ADDENDUM NUMBER 04

DATE: February 02, 2024

PROJECT: Cass District Library Edwardsburg, MI

PROJECT NUMBER: 22-1836

STEEL FRAME ELEVATIONS

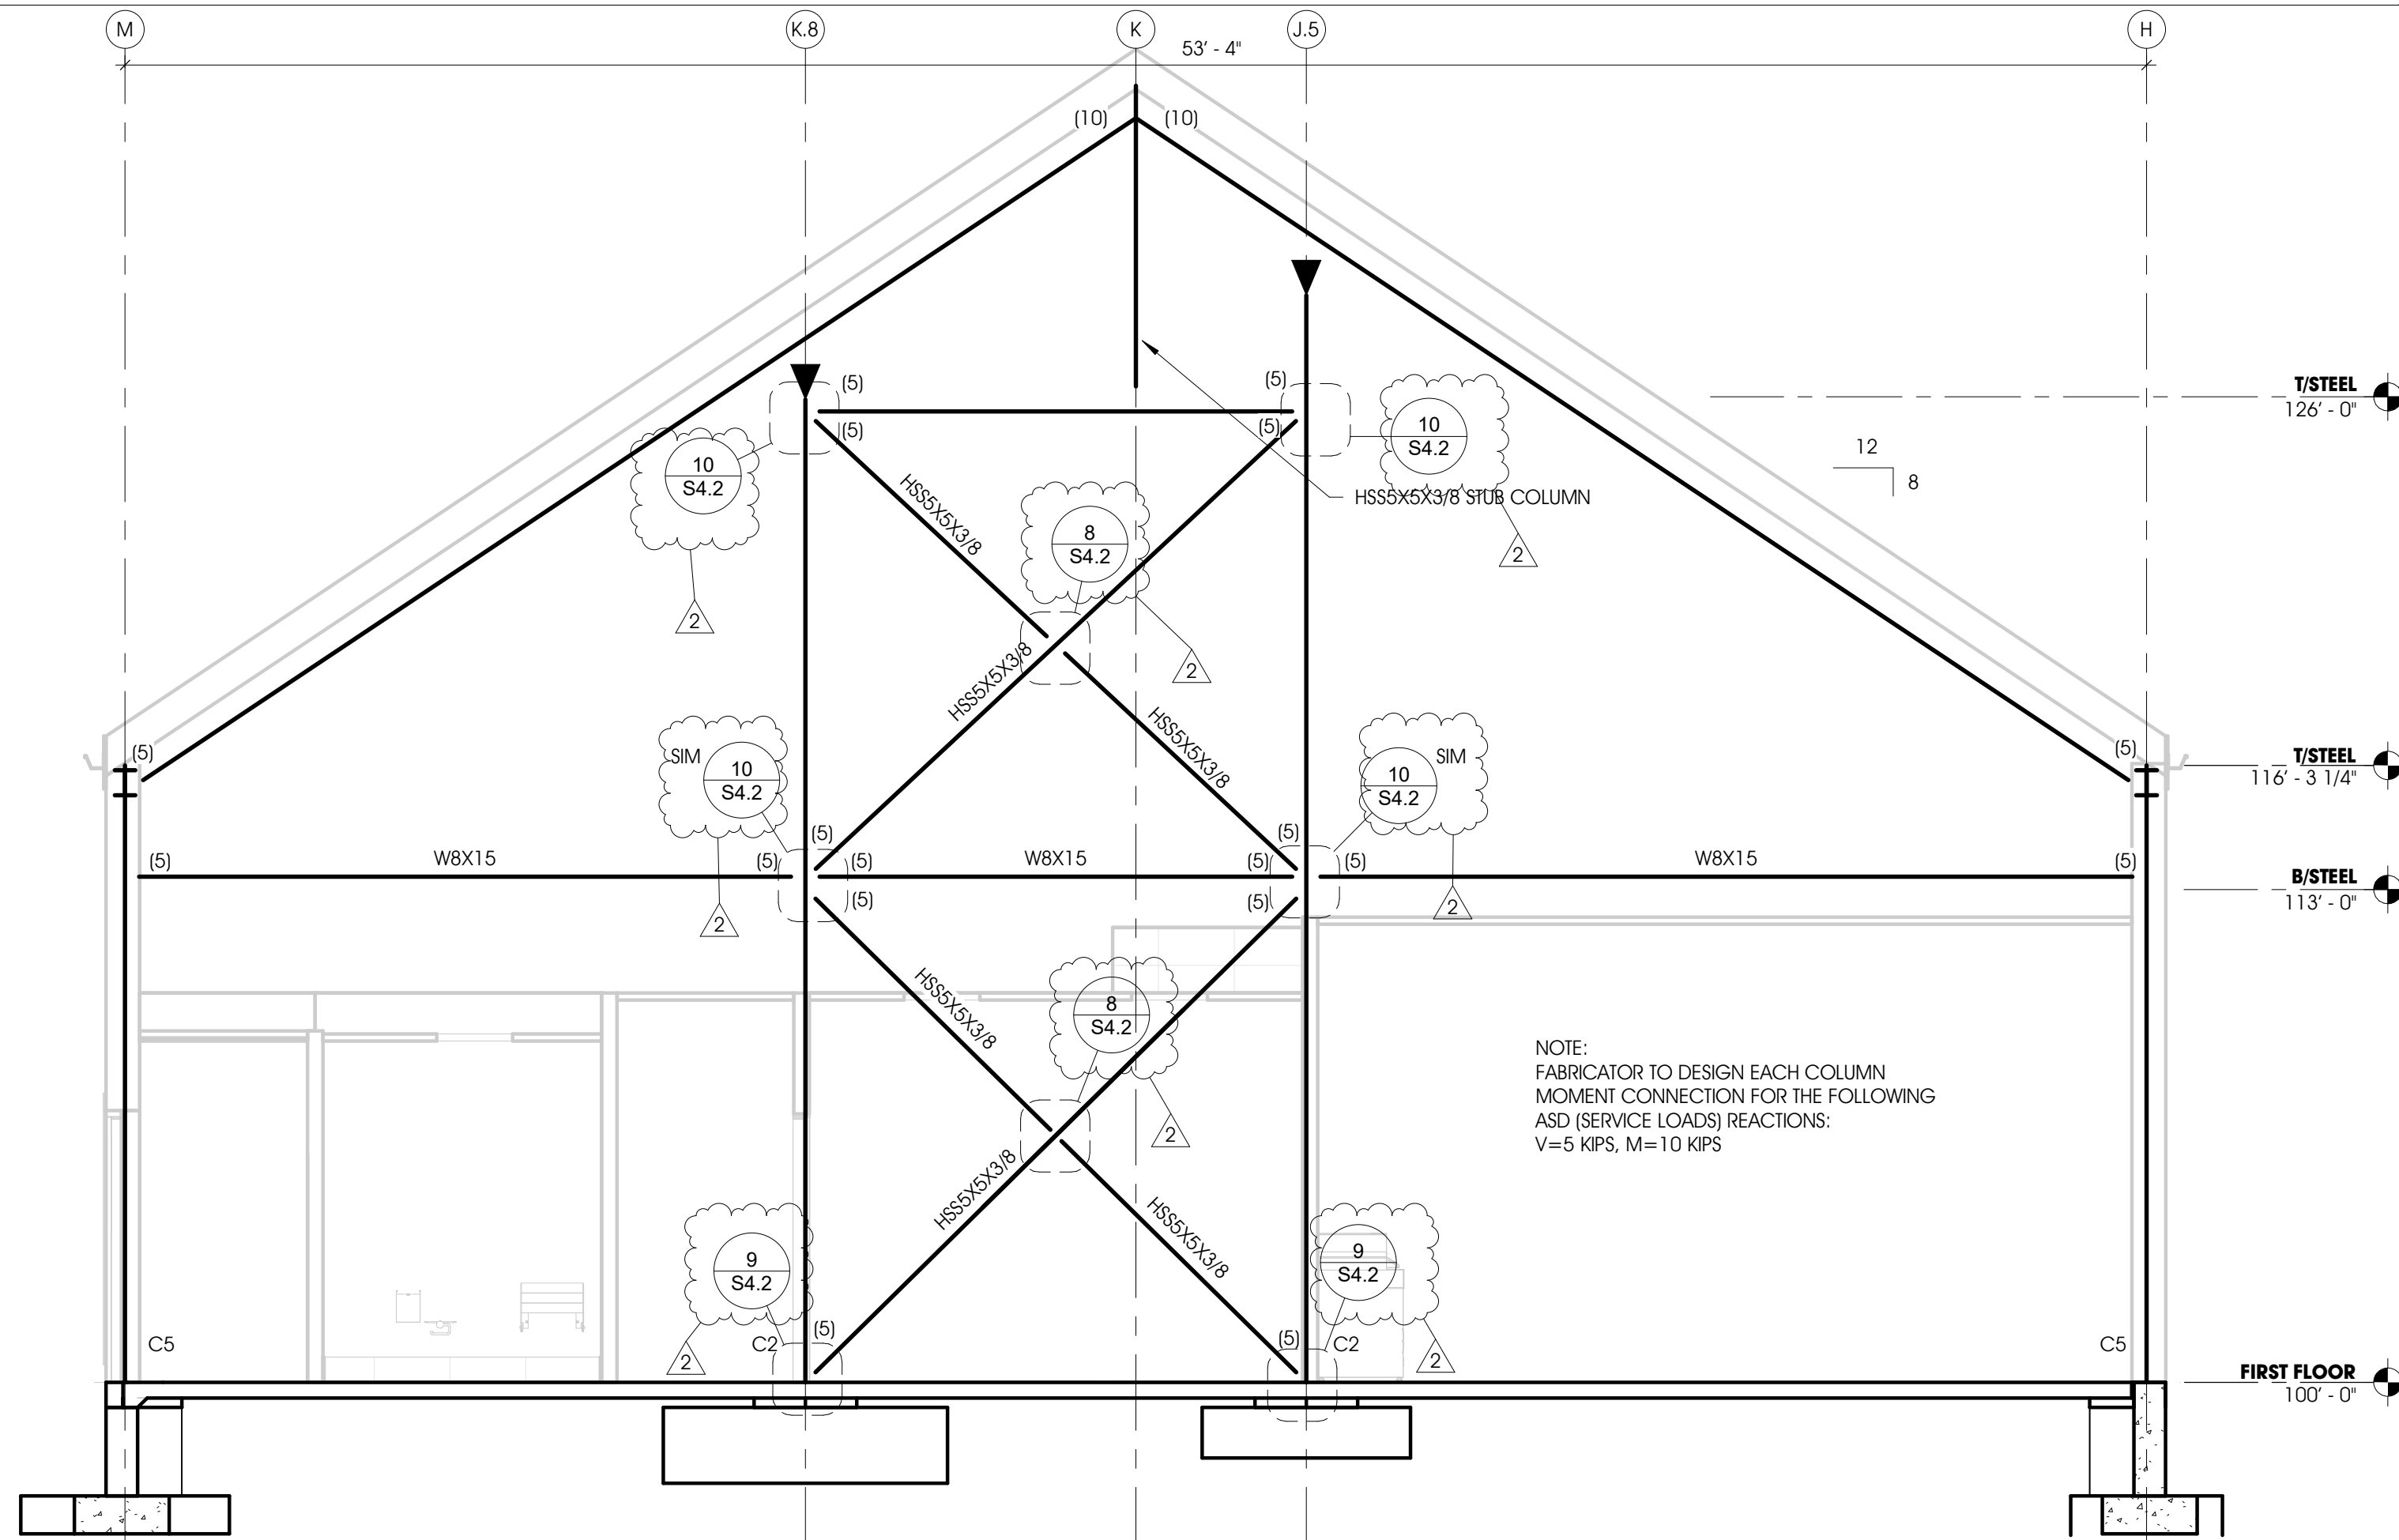
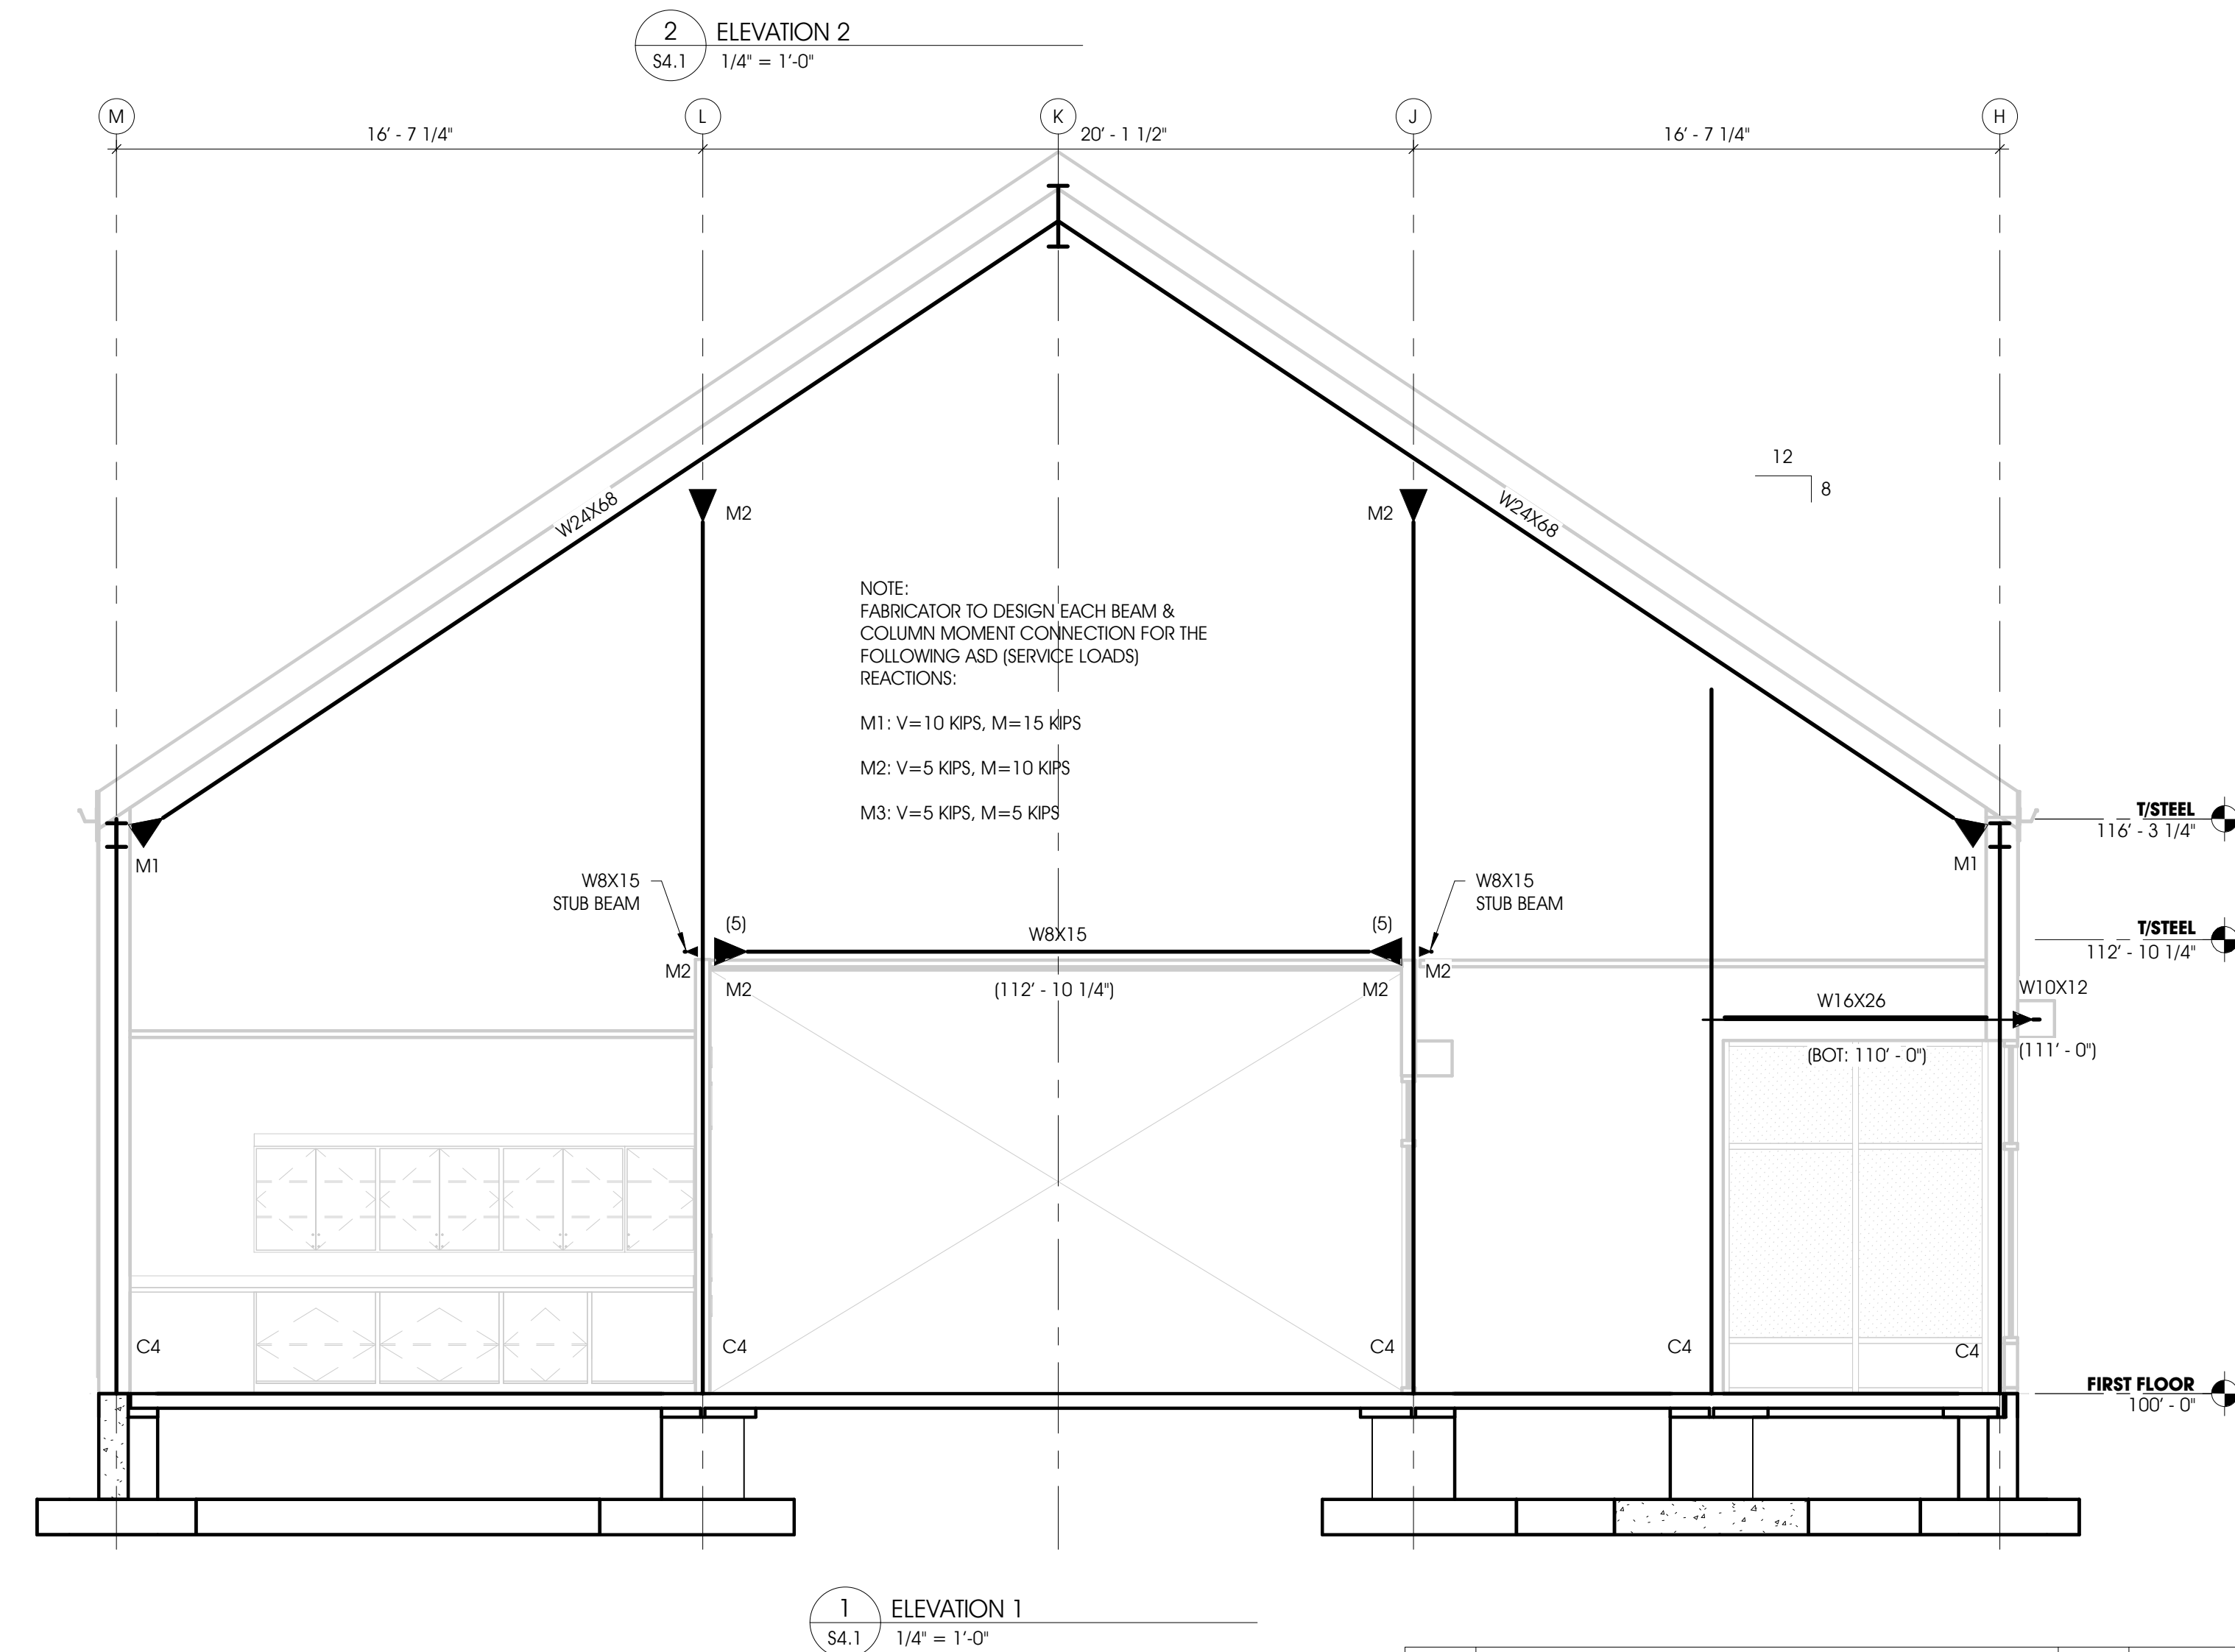
12. **CLARIFY** Bracing on detail callouts.
